Palo Verde Nuclear
Generating Station

**SUBJECT: Palo Verde Nuclear Generating Station (PVNGS)
Units 2 and 3
Docket Nos. STN 50-529/530
Additional Information to Support the Request to Extend the Second
10-Year, American Society of Mechanical Engineers Section XI,
Inservice Inspection Program Interval for Reactor Vessel Weld
Examinations – Relief Request No. 34**

Relief Request No. 34 – Additional Information Addressing the Accident Sequences Identified by the NRC during its Re-evaluation of the Risk from Pressurized Thermal Shock (PTS)

RCS Press Temp Limits Normal CTMT Conditions

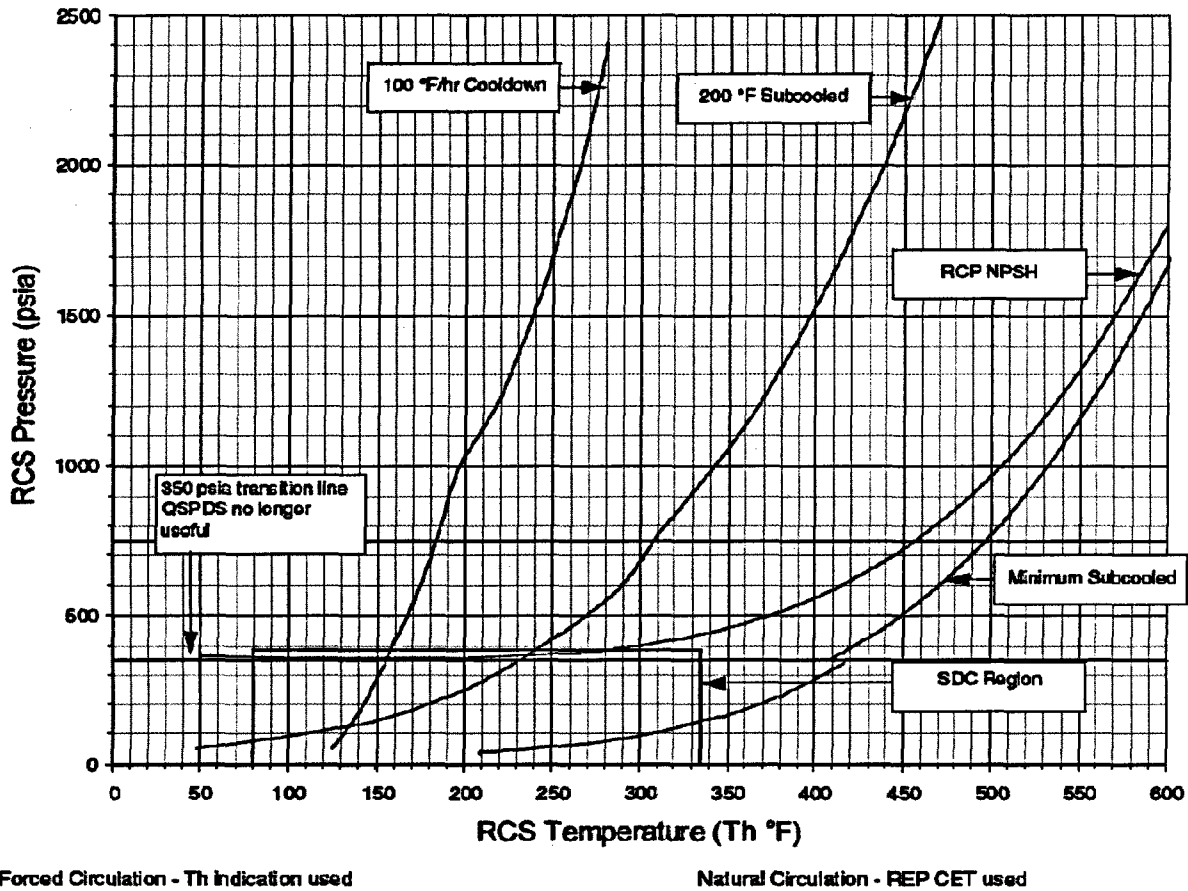
Large loss of secondary steam from steam line break or stuck-open atmospheric dump valves. Severe PTS events also require the failure to properly control auxiliary feedwater flow rate and destination (e.g., away from affected steam generators) and failure to properly control high pressure injection.

14. Stabilize RCS temperature using the lowest Tc by performing the following:
 - a. Maintain Tc within the P/T limits.
REFER TO Appendix 2, Figures
 - b. Steam the least affected Steam Generator using **ANY** of the following:
 - SBCS
 - ADVs from the Control Room
 - Appendix 18, Local ADV Operation

Stabilizing Tcold within the Pressure/Temperature (P/T) limits precludes PTS. EOP 40EP-9EO05 also contains the guidance for throttling HPSI when throttle criteria are met (same as Step 27 from LOCA). EOP 40EP-9EO10, "Standard Appendices," contains all of the figures, tables, charts, graphs and sub-procedures associated with performance of the EOPs.

Appendix 2 of 40EP-9EO10 shows the acceptable areas of operation and delineates where PTS becomes a concern (the 200 degree subcooled line). Appendix 2 is provided below:
